SWCPP Ref. No.:	PPSSWC-65
DA No.:	DA20/0148
PROPOSED DEVELOPMENT:	Construction of Part 14 Storey, Part 37 Storey Mixed Use Development including One (1) Level of Basement Car Parking, Five (5) Storey Podium Containing Car Parking, Ground Floor Commercial, 356 Residential Apartments, New Public Road & Associated Site Works - Lot 300 DP 1243401,87 - 93 Union Road, PENRITH NSW 2750
APPLICANT:	Toga Penrith Developments Pty Ltd
REPORT BY:	Kathryn Saunders, Senior Development Assessment Planner, Penrith City Council

Assessment Report

Figure 4 (below): Excerpt from the applicant's SJB Architectural Plan - Ground Floor Plan, AR-1-1010 rev 73.

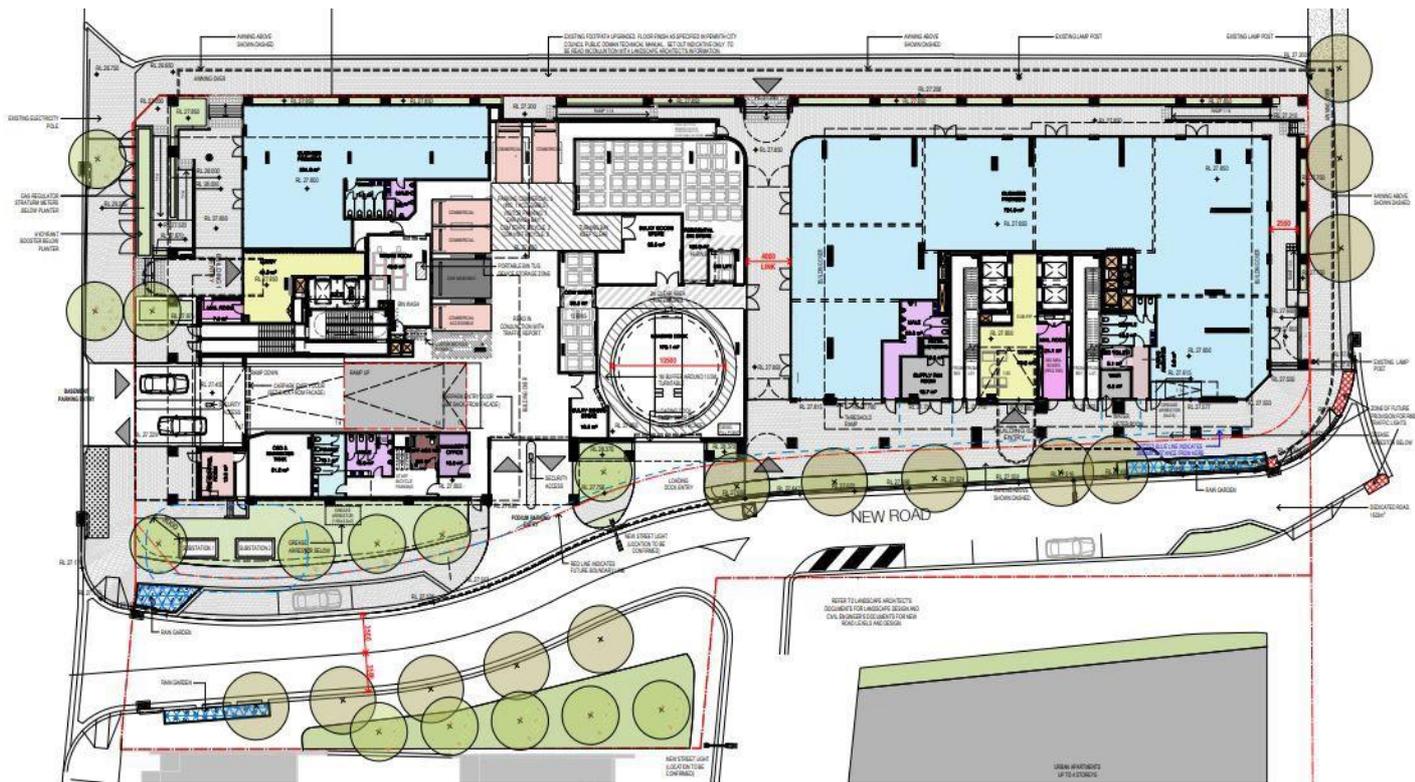
No plans of any future signalised intersection are provided as part of the applicant's Community Infrastructure Offer. The applicant's civil, architectural or landscape plans do not overlay a possible future signalized intersection and there is little detail provided as to how the interim round-a-bout connection indicated on the plans will overlay on a final signalised intersection design which is reference in the applicant's CI Offer.

The submitted civil plans show a possible future 'interim' intersection on the southern side of High Street. This arrangement is not supported.

Figure 5 (below): Excerpt from applicant's civil works plan (High Street and new road intersection).

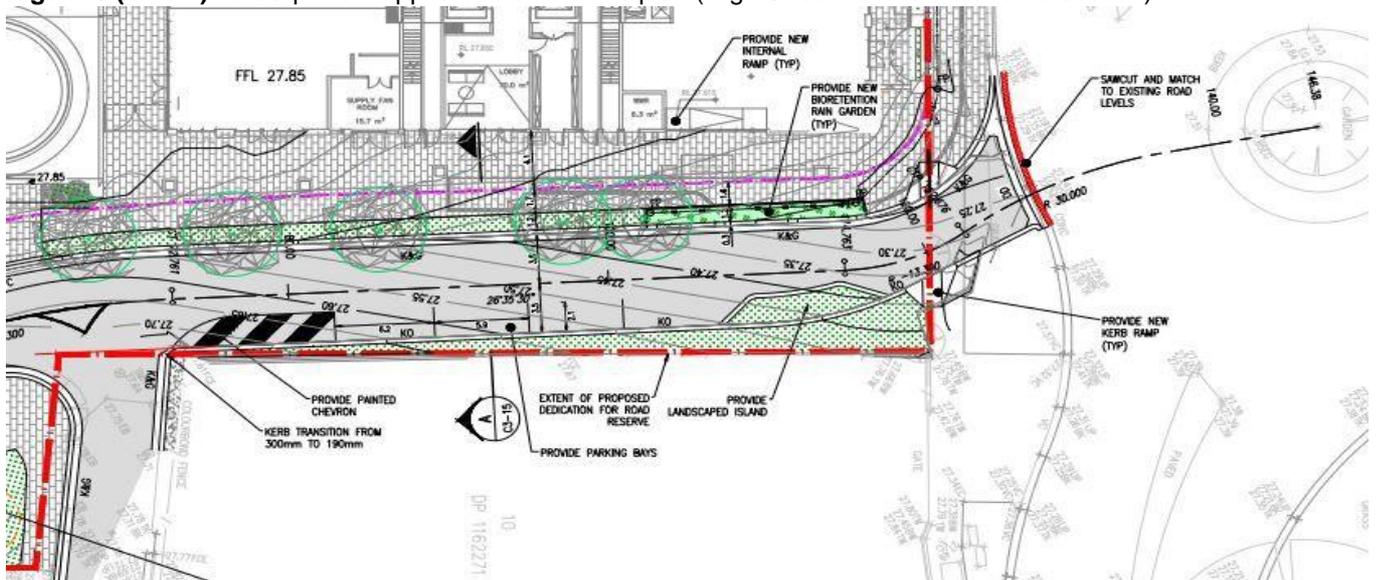
No information is provided to enable an understanding or assessment of the extent of civil works required for the installation of the signalised intersection. No overlay of the physical final dimensional needs of the intersection have been provided on the architectural or civil plan sets or elsewhere, which would enable Council or TfNSW to be satisfied that traffic signals could be achieved and subsequently be supported. TfNSW have not been referred a development proposal that includes a signalised intersection.

Sufficient dimensional detail is not provided to confirm that a signalised intersection will not be hindered by the Urban Apartments proposal under DA20/0167 (currently under assessment) as it is not clear if the proposed building is setback sufficiently to allow for the required roadway verge inclusive of pedestrian pavement, and the intersection's required third lane (westbound left turn from High Street into the new road).

Figure 8 (below): Excerpt from applicant's ground floor plan indicating bins stored at ground floor.

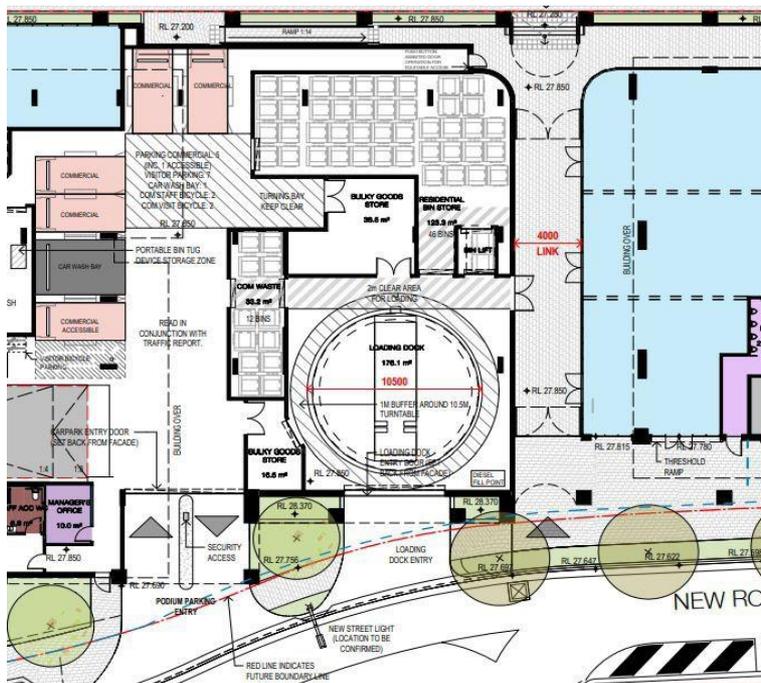
The development is supplied with dual waste chutes for each level of the development. The proposal does not provide for a bulky waste storage cupboard on each floor near the chutes. This is required to allow for residents to place bulky items like cardboard boxes so that the building manager can relocate these to the bin rooms rather and will avoid chutes being blocked.

Figure 9 (below): Excerpt from applicant's landscape plan indicating services located along street elevations.

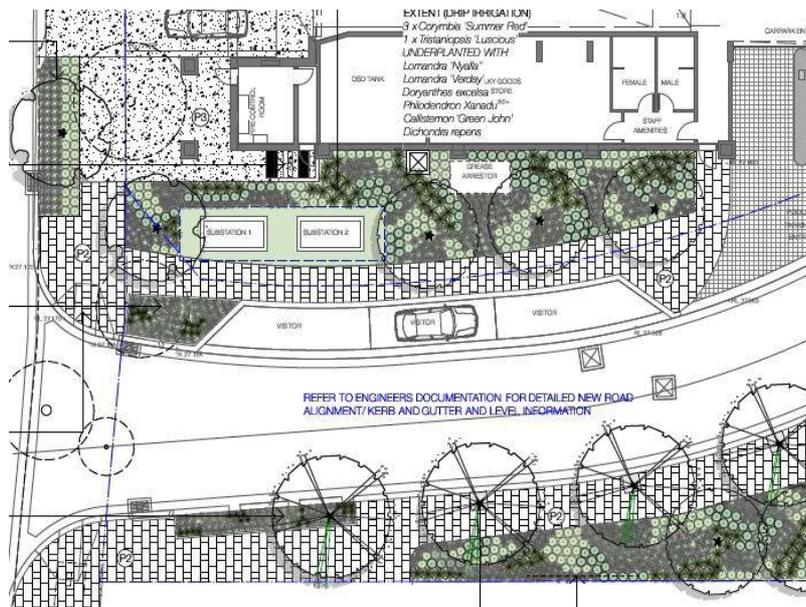
The landscaping proposed adjacent to the eastern elevation (south end of new road) is dominated by services including two pad mounted electrical substations. These detract from the quality of the street and should be located within the design of the development in line with the high expectations of a design excellence winning scheme. It is noted that the adjacent development at 614-632 High Street (DA20/0167 also the subject of a design excellence waiver) is designed with internally located electrical substations.

Figure 6 (above): Excerpt from PDCP 2014 - Precinct 1 Design Principles - Figure E11.26

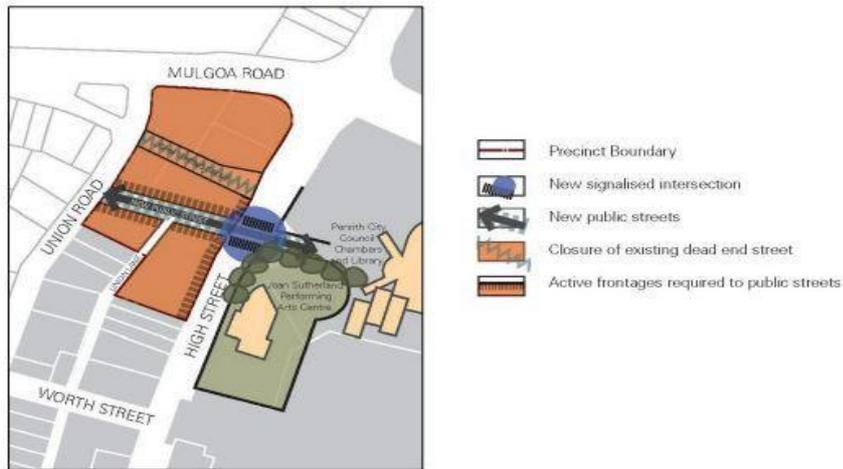
The proposed development does not assist in the delivery of the above with the exception of an interim arrangement for the north-south link and an activated eastern edge fronting the new street. Insufficient detail is provided to satisfy Council that the signalled intersection proposed as part of an offer of Community Infrastructure can be delivered (refer to discussion under PLEP).
